Studebaker

# SERVICE BULLETIN

NO. 234

1949

## ELIMINATION OF CLUTCH OPERATING SHAFT RATTLE — 6G-9G, 14A-17A

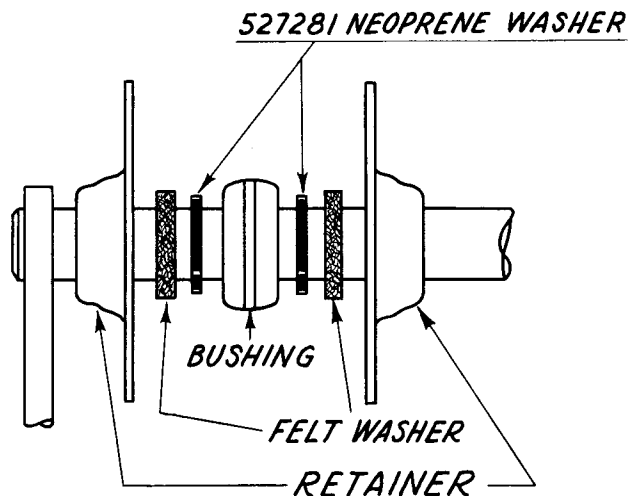
A rattle in the clutch operating shaft can be eliminated in the 6G-9G models inclusive and 14A-17A models inclusive by the use of two Neoprene washers, Part No. 527281. Two of these washers, used as directed below and described in the accompanying illustration, will prevent noise in the clutch operating shaft parts, in cars produced prior to Serial Nos. G485212 (9G) and 4404905 (17A).

1. Remove operating shaft and bushing and retainer assembly and disassemble.
2. Inspect shaft. If it shows signs of wear, replace shaft.
3. Disassemble the bushing and retainer assembly, replace any worn parts, and reassemble, using two of the new Neoprene washers, Part No. 527281. The parts should be assembled in the following order:

- (a) Metal retainer
- (b) Felt washer
- (c) Neoprene washer
- (d) Bushing
- (e) Neoprene washer
- (f) Felt washer
- (g) Metal retainer

4. Thoroughly lubricate the assembly with SAE 30 engine oil and reassemble with the shaft in the car.

## INSTALLATION OF FLOOR MATS AND CARPETS — 9G, 17A

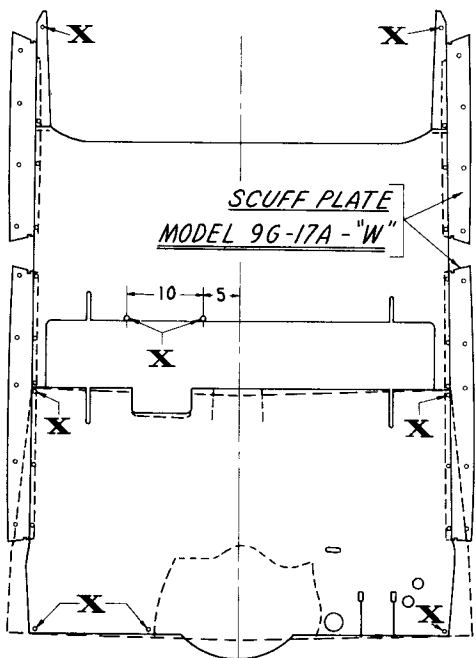
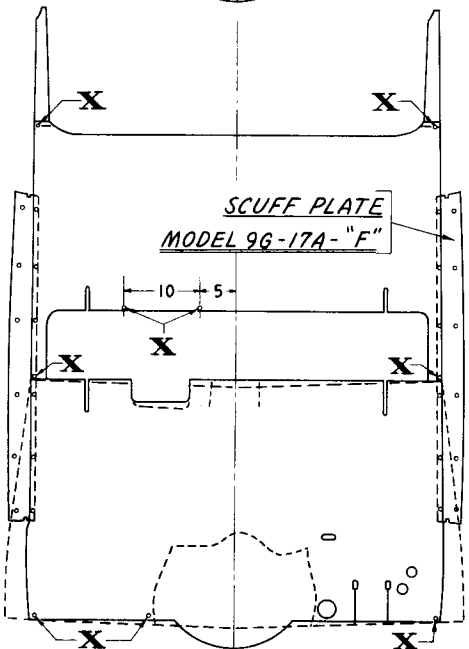
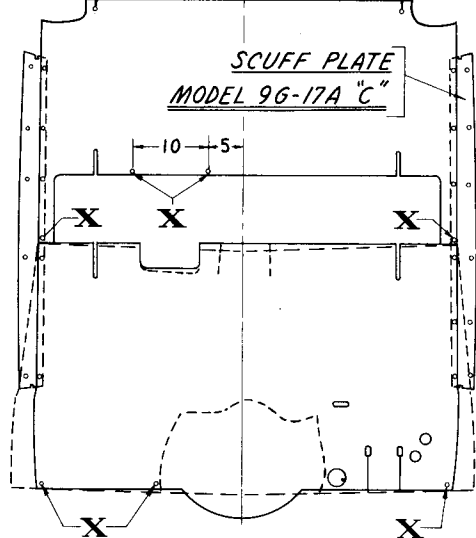
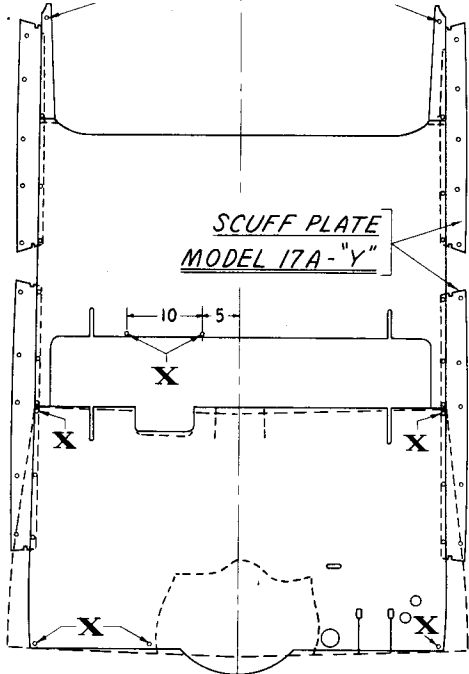
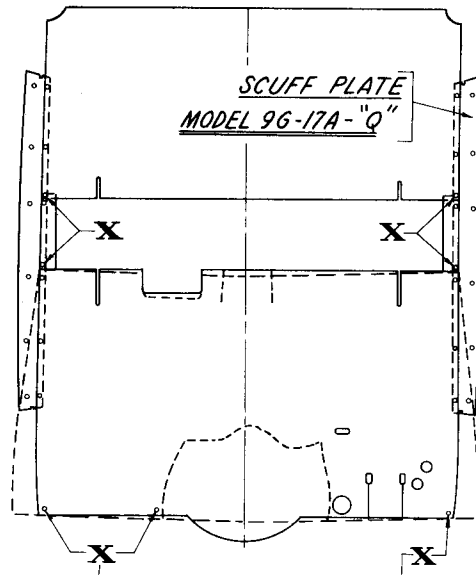
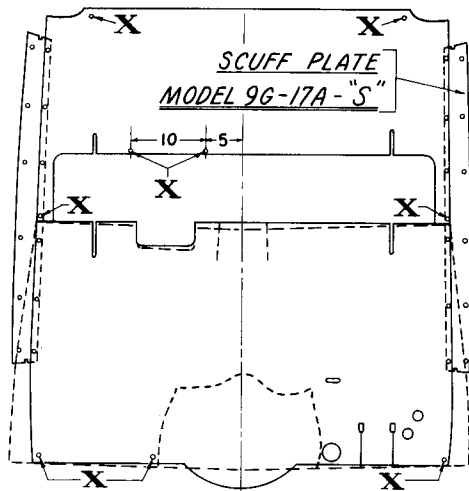
The drawings at the right show the location of installation screws for installing floor mats and carpets in the various body styles of 9G Champion and 17A Commander models.

The inner scuff plate screws are removed, mat or carpet laid, and the scuff plate screws reinstalled to fasten the floor covering at those points. Additional screws (provided in an envelope placed in the package compartment) are to be installed at the points designated by the large letter X on the drawings.

The drawings at the right are of a L.H.C. car and the locations of the carpet installation screws on R.H.C. cars are reversed.

**SUPPRESSION AT VOLTAGE REGULATOR**

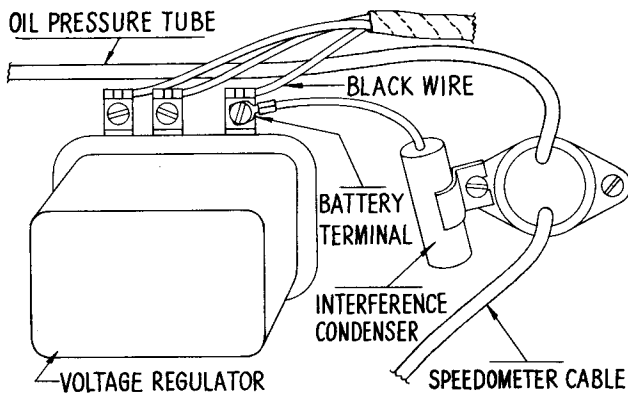
One condenser is fastened to the battery (BAT) terminal of the current and voltage regulator and the condenser bracket is grounded to the engine side of the dash at the innermost mounting screw of the grommet containing the speedometer cable and the oil pressure gage tube, as shown below.

**SUPPRESSION AT IGNITION SWITCH**

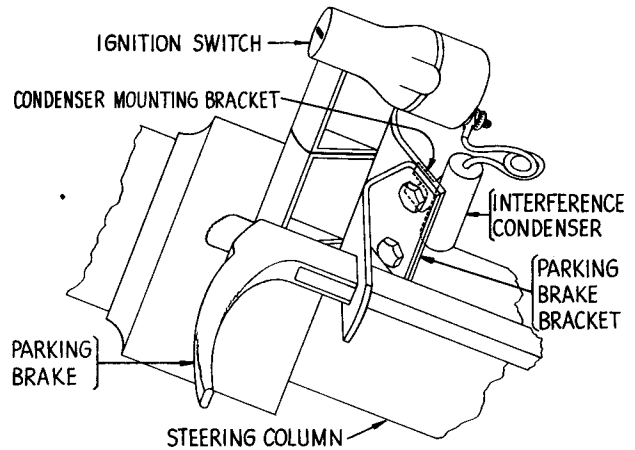
One condenser is fastened to the accessory terminal of the ignition switch and the condenser bracket is grounded to the right hand parking brake handle support bracket mounting screw, as shown at the top of next column.

**ELIMINATION OF BRAKE SQUEAK SELF-ADJUSTING PLUG - 6G-9G; 14A-17A; 2R5**

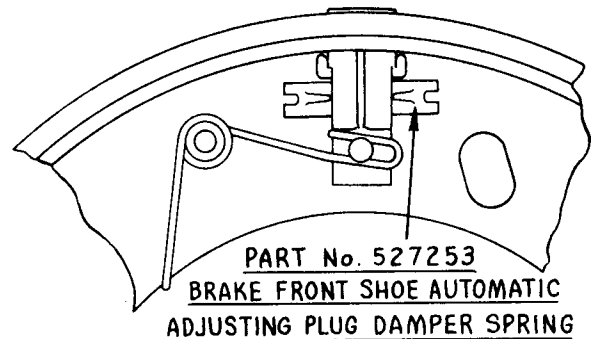
A brake squeak that can be traced to the self-adjusting plug of the forward brake shoe on 6G, 7G, 8G and 9G Champion models and 14A, 15A, 16A and 17A Commander models and 2R5 series truck models, can be eliminated by the use of a Damper Spring, Part No. 527253. The spring is inserted between the self-adjusting plug and the web of the brake shoe at all four wheels. This change was incorporated in production on all passenger cars and 2R5 trucks beginning approximately October 1, 1949.

1. Remove the wheel, hub and drum assembly.
2. Slide the spring, Part No. 527253, between the flat side of the self-adjusting plug and the web of the brake shoe, with the concave face of the spring toward the web of the shoe.
3. Center the spring and make sure the tabs on the spring on either side of the self-adjusting plug are raised to hold the spring in position.
4. Push self-adjusting plug down until it is flush with or slightly below the surface of the brake lining.
5. Install the wheel, hub and drum assembly.
6. Make brake application and adjust brakes as required.

## INTERFERENCE BETWEEN OIL PAN BAFFLE AND CRANKSHAFT - 9G, 2R5, 2R10, 2R15

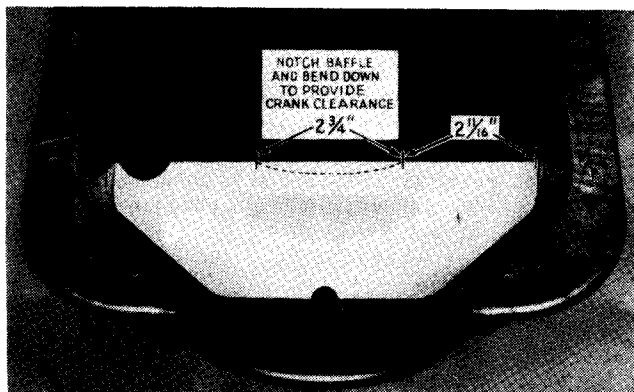
Engine noise in a few cases has resulted from interference between the oil pan baffle and the cheek of the No. 5 crank on the crankshaft. In production, a notch and a depression have been placed in the baffle in the oil pan to provide clearance for the crank cheek at this location.

Should any interference of this kind be noticed in Champion-type engines brought to your service department, it will be necessary to remove the oil pan, notch the baffle and bend it downward at the point of interference as shown in the accompanying illustration.
